Department of Energy
Savannah River Operations Office
P.O. Box A
Aiken, South Carolina 29802

SUBJECT: Fifth Five-Year Remedy Review Report for Savannah River Site Operable Units with Operating Equipment (U) Aiken, South Carolina (SRNS-RP-2017-00567, Redline Revision 1, July 2018) (Redline Pages), Savannah River Site Fifth Five-Year Remedy Review Report for Savannah River Site Operable Units with Operating Equipment Fact Sheet (ERD-EN-2017-0076, July 2018) (Redline Pages), and Savannah River Site's Responses to the Regulatory Comments on the Revision 0 Document

3. Savannah River Site's Responses to South Carolina Department of Health and Environmental Control's Comments on Fifth Five-Year Remedy Review Report for Savannah River Site Operable Units with Operating Equipment (U) Aiken, South Carolina (SRNS-RP-2017-00567, Revision 0, December 2017)

4. Savannah River Site's Responses to U.S. Environmental Protection Agency's Comments on Fifth Five-Year Remedy Review Report for Savannah River Site Operable Units with Operating Equipment (U) Aiken, South Carolina (SRNS-RP-2017-00567, Revision 0, December 2017)

Figure F-3. CBRP OU SVE Stations

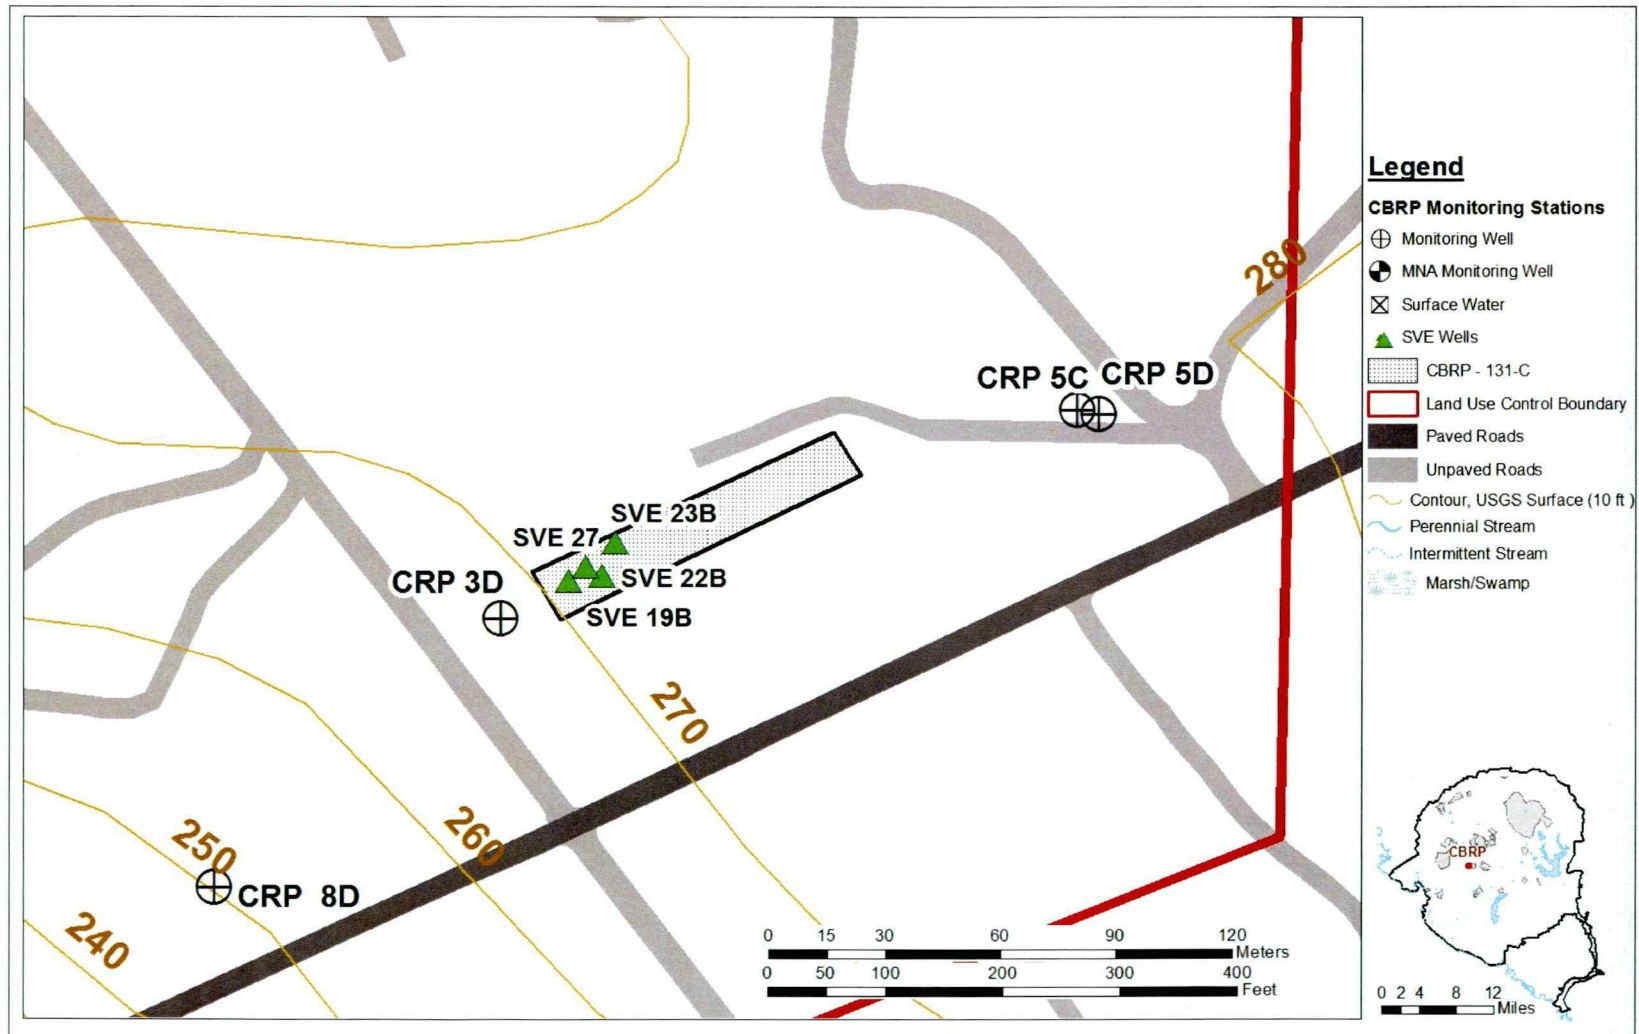
1. Figure F-2, CBRP OU LUC Boundary and Monitoring Stations, page F-16. This figure, which shows the LUC boundary of CBRP, contains “SVE Well” in the legend, but the scope of the figure does not allow the locations of the four operating MicroBlower™ SVE well to be clearly seen. Please include an additional figure showing the locations of the wells, similar to Figure L-3 in Appendix L.

Response: Agree.

Figure F-3 CBRP OU SVE Stations will be added to Appendix F as requested. Figure F-3 is attached to the comment responses.
